The Northern Road Upgrade – Mersey Road, Bringelly to Glenmore Parkway, Glenmore Park

Submissions and Preferred Infrastructure Report Volume 1: Main Report

Roads and Maritime Services | December, 2017

Figure 2-2 Cross section of the proposed culvert at the unnamed tributary of Surveyors Creek

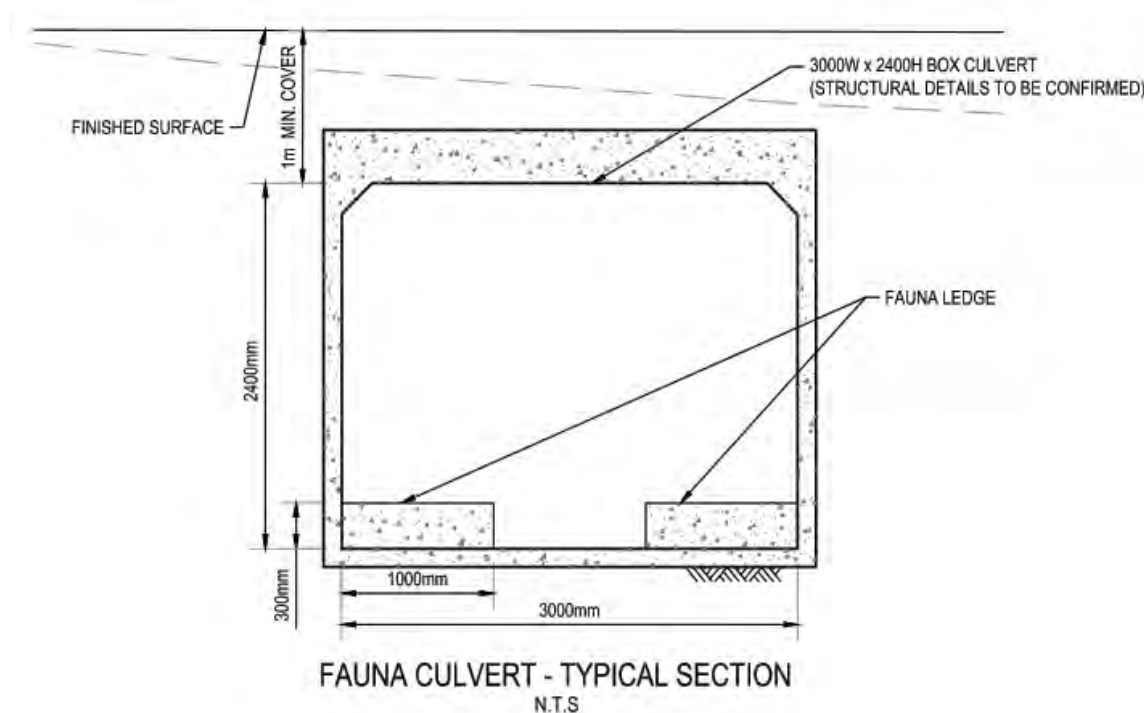
Connectivity between the Mulgoa Nature Reserve and the DEOH via Regional Corridor 17 (Surveyors Creek corridor) would be planned for in the future with construction of a fauna crossing to allow for future connectivity to the DEOH land. The proposed fauna crossing is currently a 2.4 m high dry passage underpass (refer to Figure 2-2). This is considered suitable for larger species such as the Eastern Grey Kangaroo based on monitoring results from Pacific Highway projects. However, the potential to increase the height of this underpass would be investigated during detailed design of project where reasonable and feasible. The culvert would lead from the Surveyors Creek corridor under the road and would exit at the new DEOH fencing within the road reserve. There is a second culvert that leads from this road reserve into the DEOH site. For DEOH security reasons, this second culvert would be blocked via bars at about 180mm spacing onto DEOH land. This is to prevent the public from gaining unauthorised access to the DEOH land through the underpass and to prevent animals from exiting the culvert onto the roadway. The bars would remain in place until a change in potential future land use would allow the removal of the DEOH fencing. While this would preclude larger animals crossing into the DEOH in the short term,

The requirement for fauna passage at Surveyors and Badgerys Creek crossings have been incorporated into the revised environmental management measures for the project (refer to Chapter 6).

Figure 2-3 Cross section of the proposed culvert at Badgerys Creek

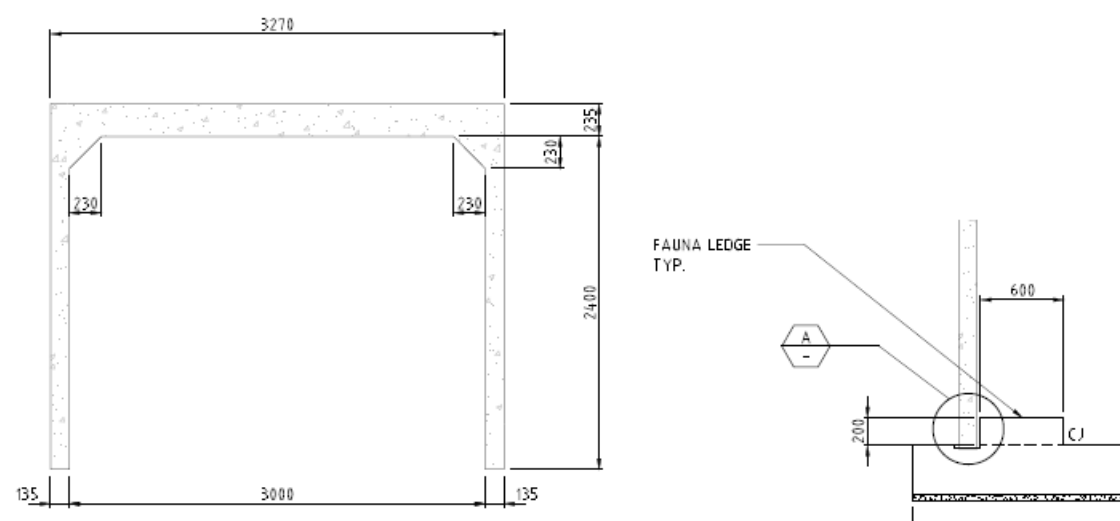
Fauna passage would also be provided at Badgerys Creek with the construction of a fauna friendly drainage culvert of similar internal dimensions to the Surveyors Creek / DEOH culvert (refer to Figure 2-3).

Figure 4-1 | Overview of design refinements for the project

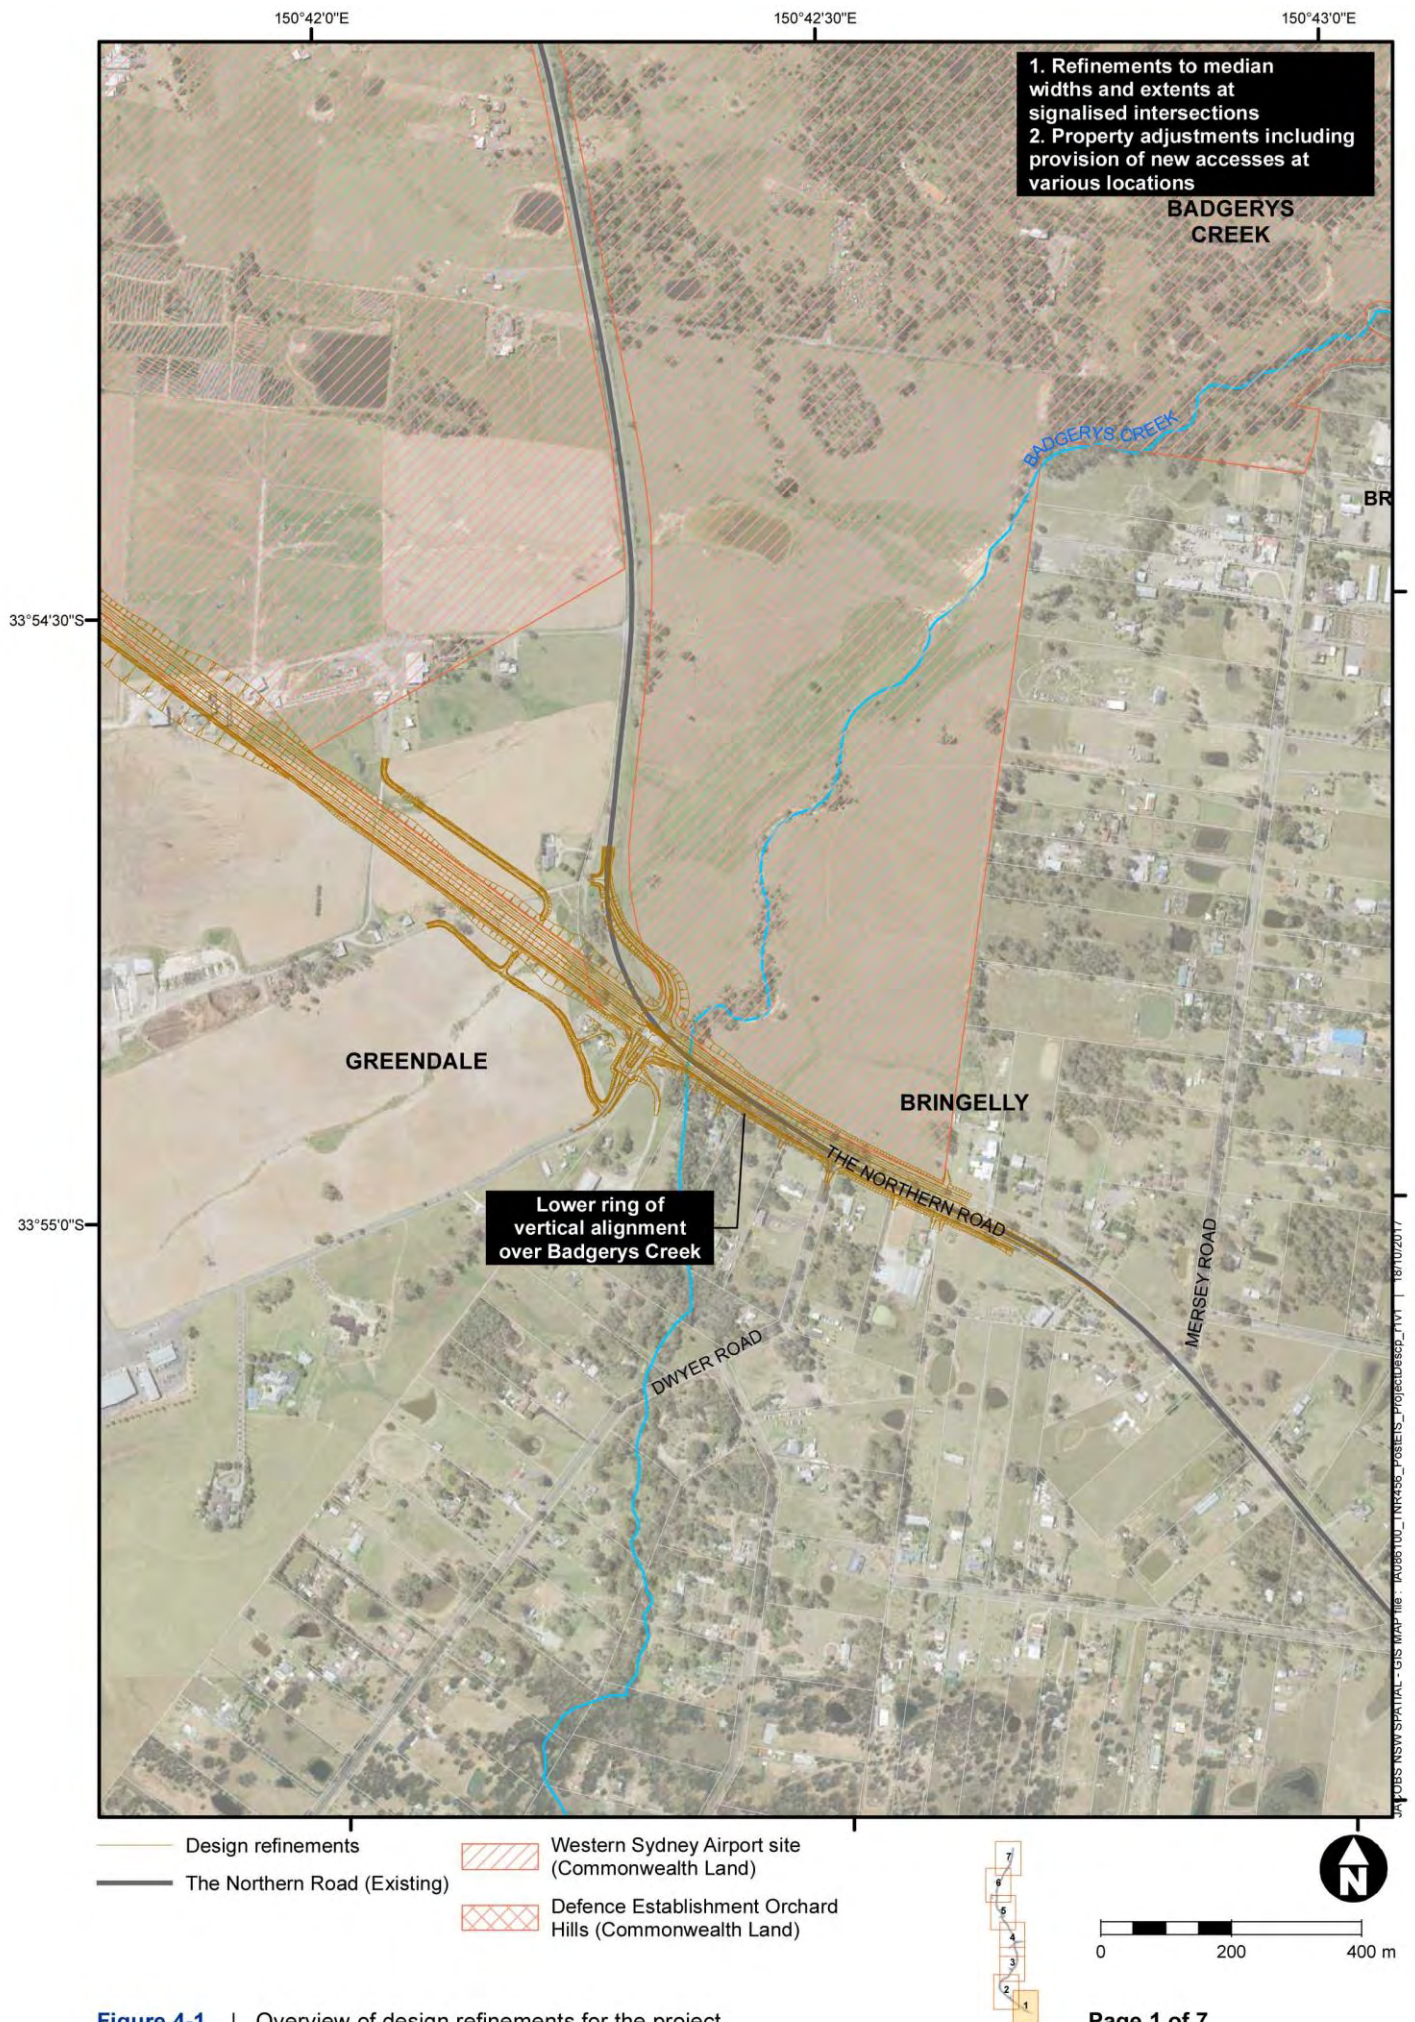
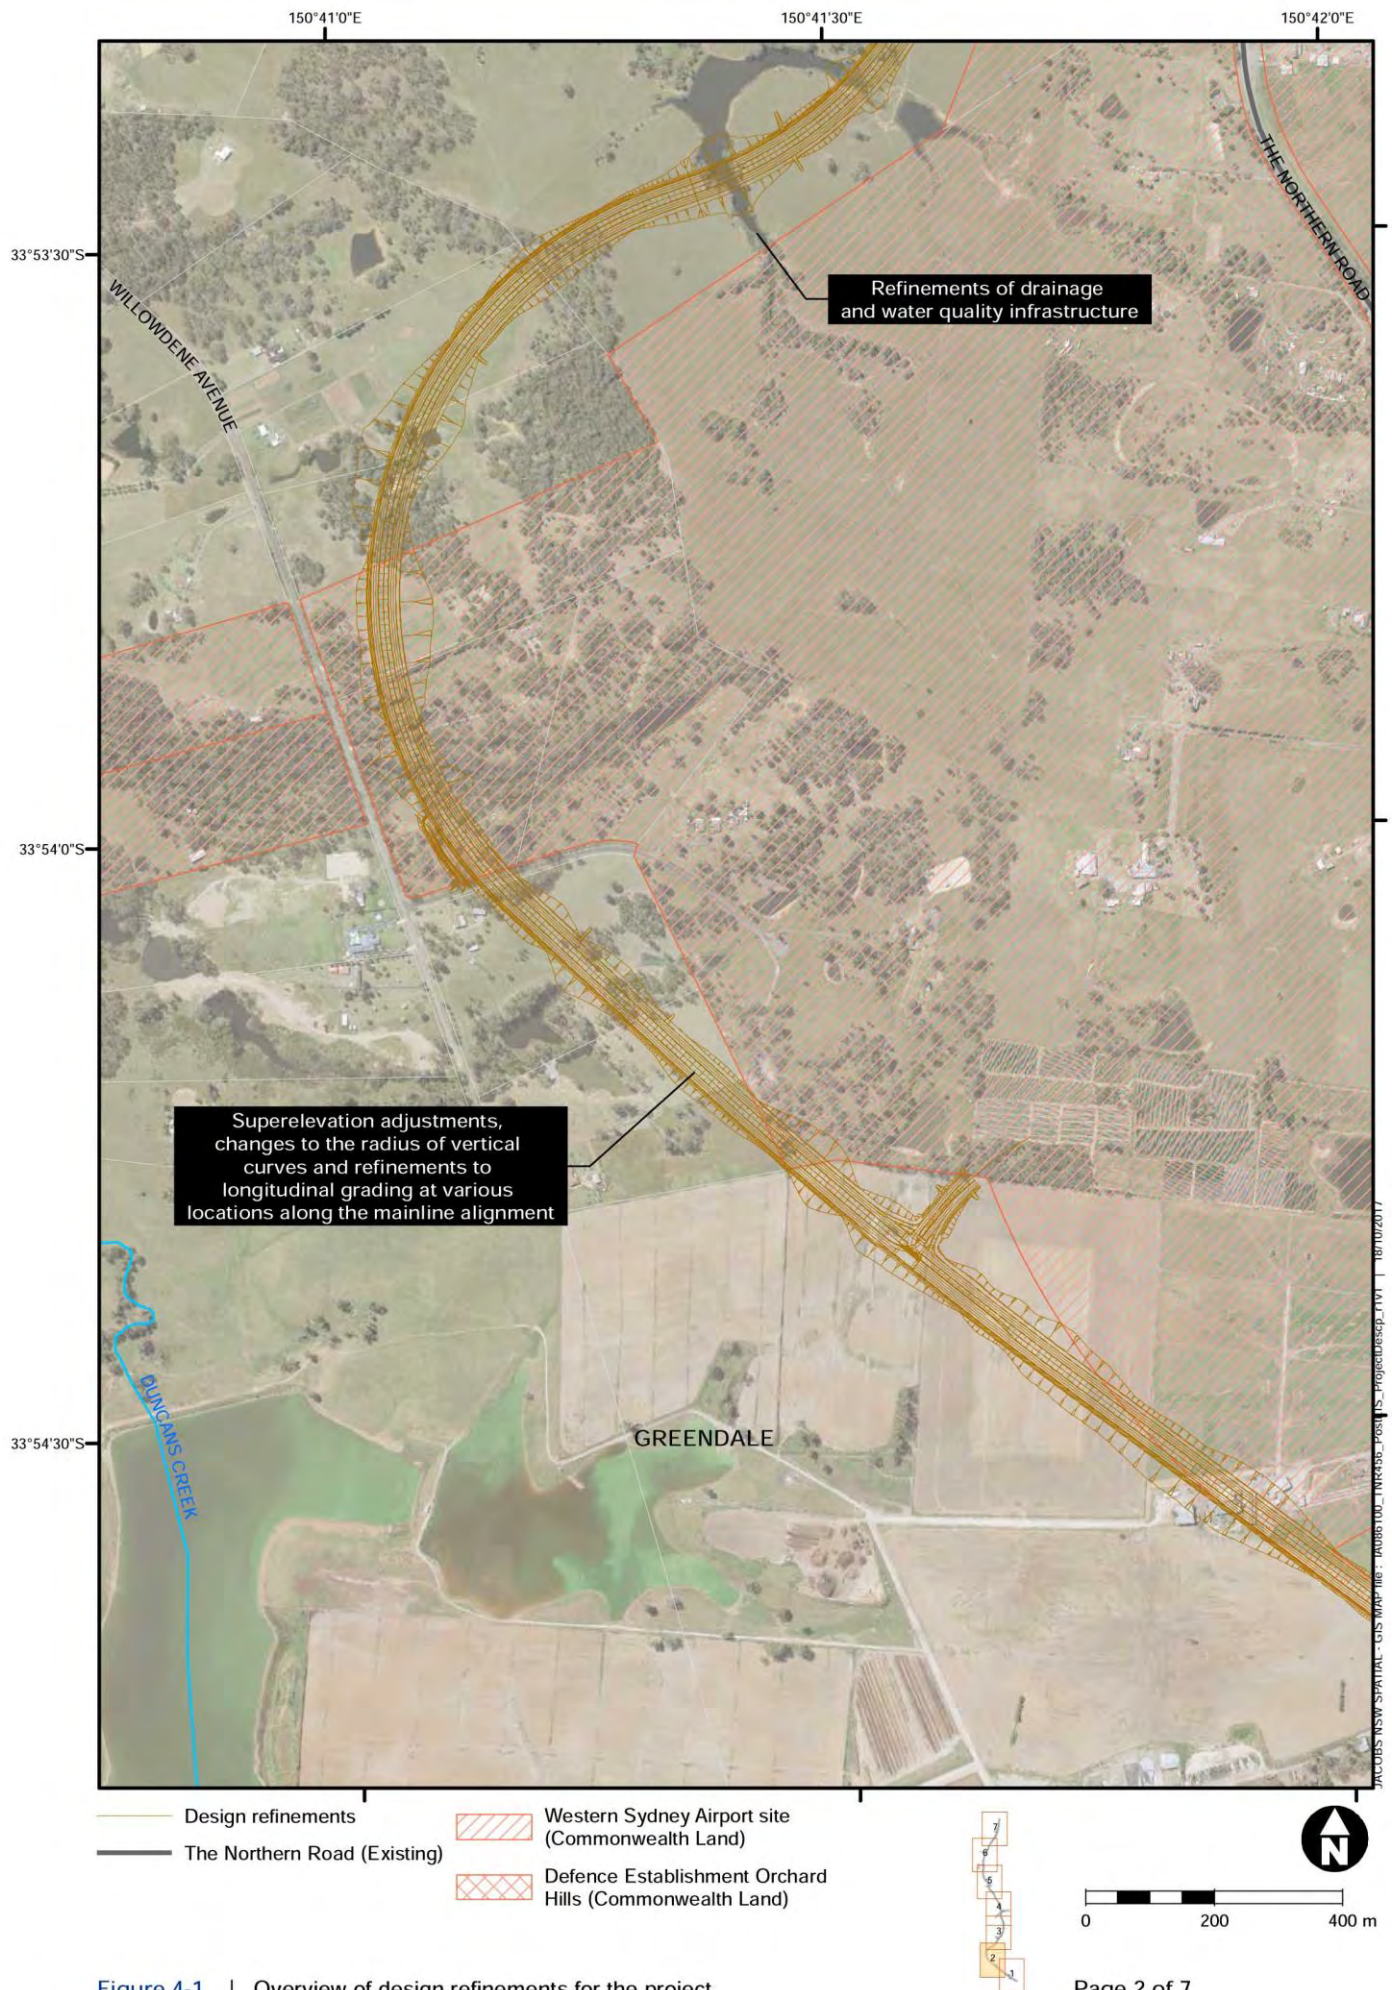
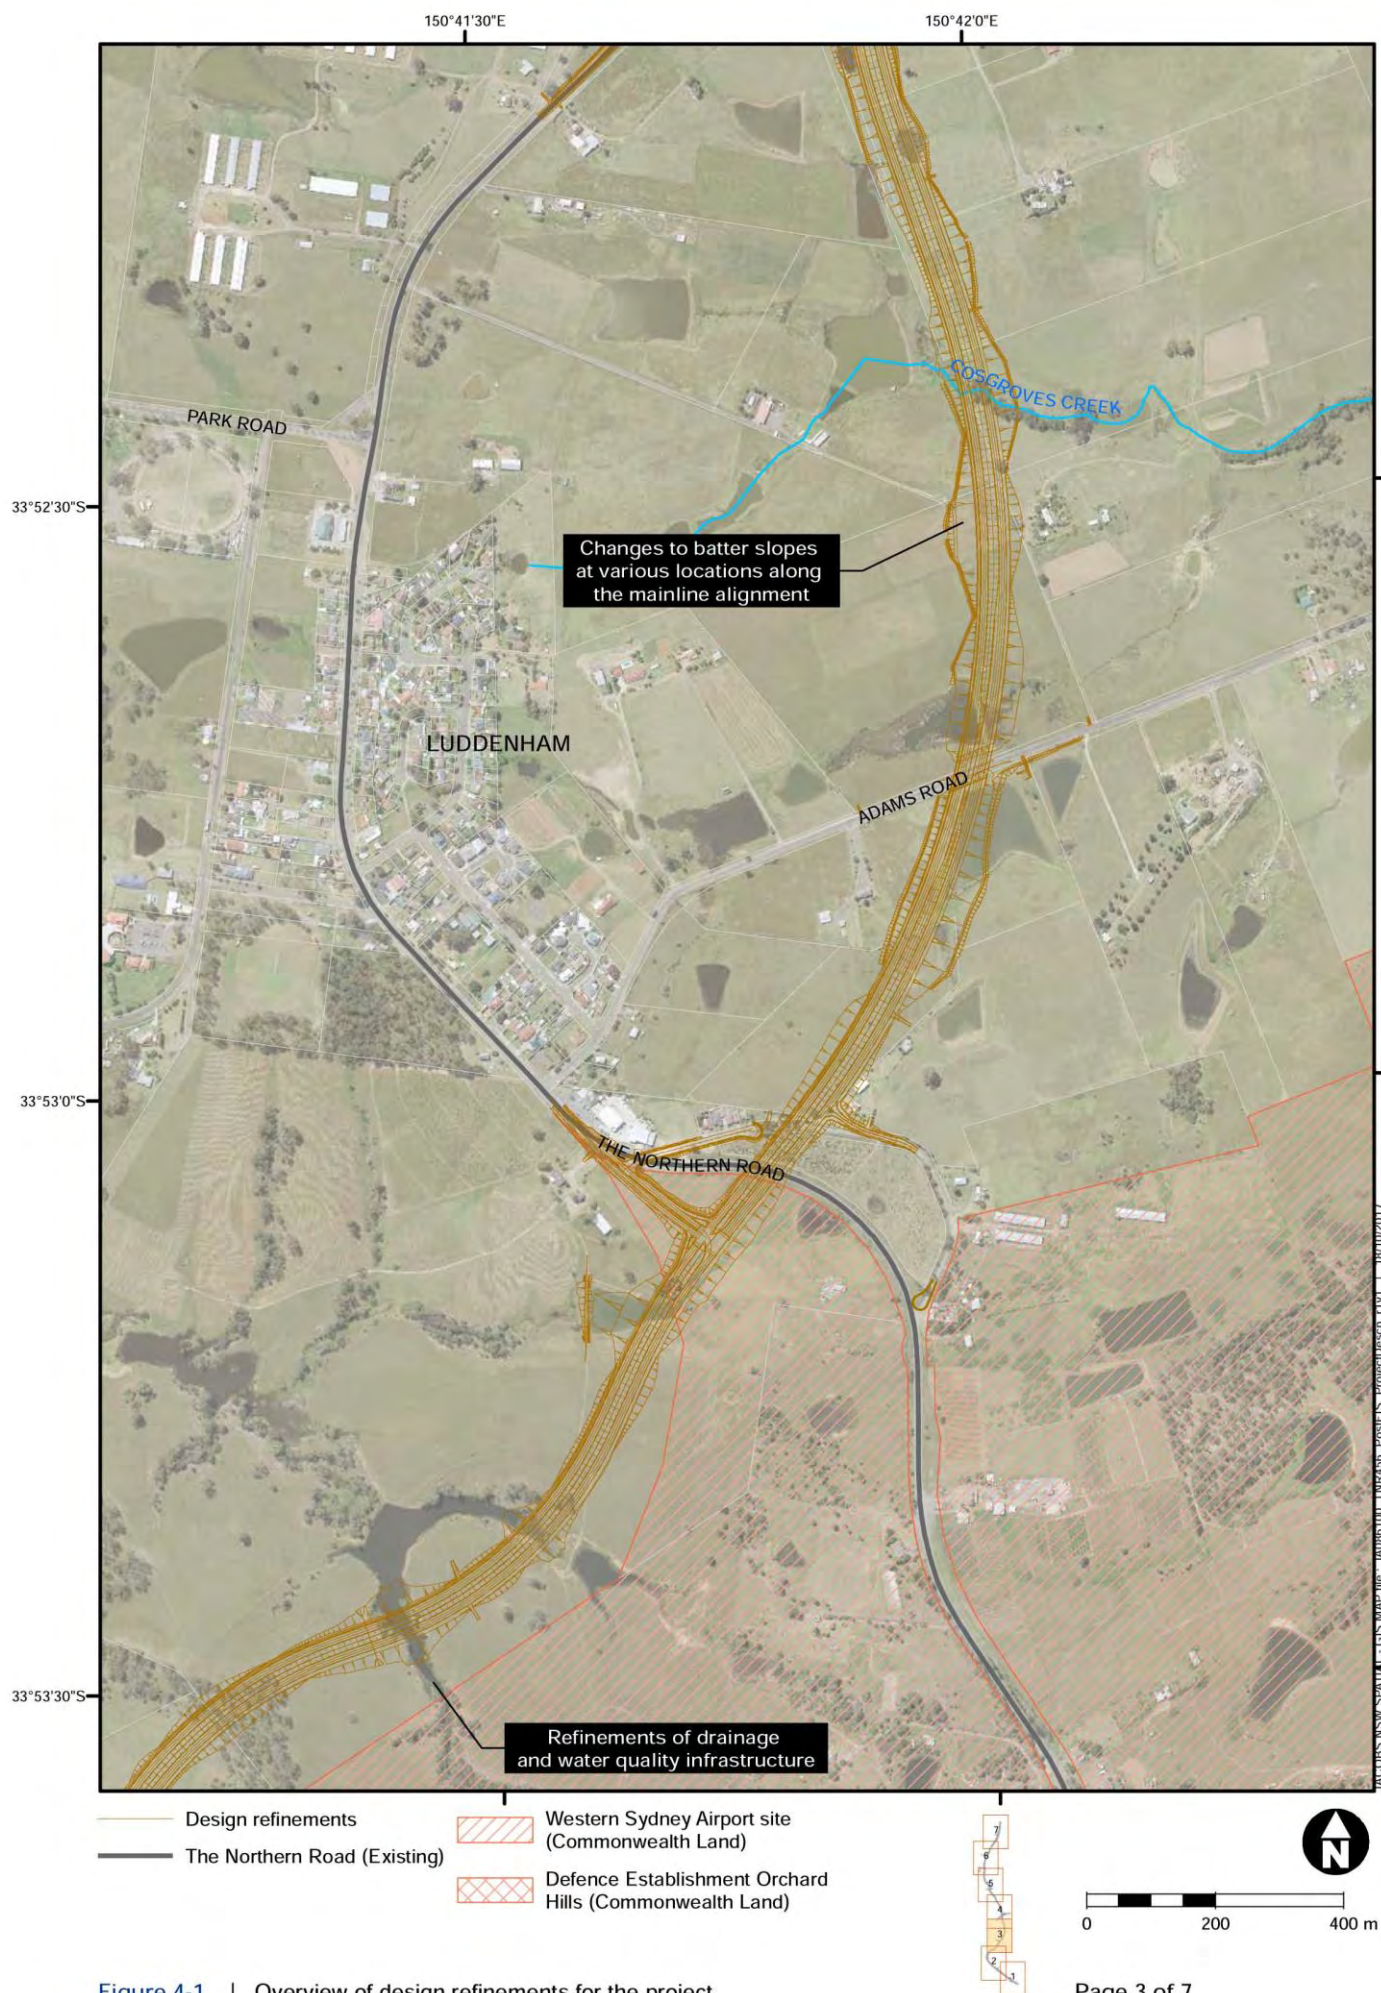
An overview of the design refinements for the project is provided in Table 4-1. This includes details of the justification for the change and any further environmental assessment undertaken since exhibition of the EIS in order to assess the change. Figure 4-2 provides an overview of the key design refinements.
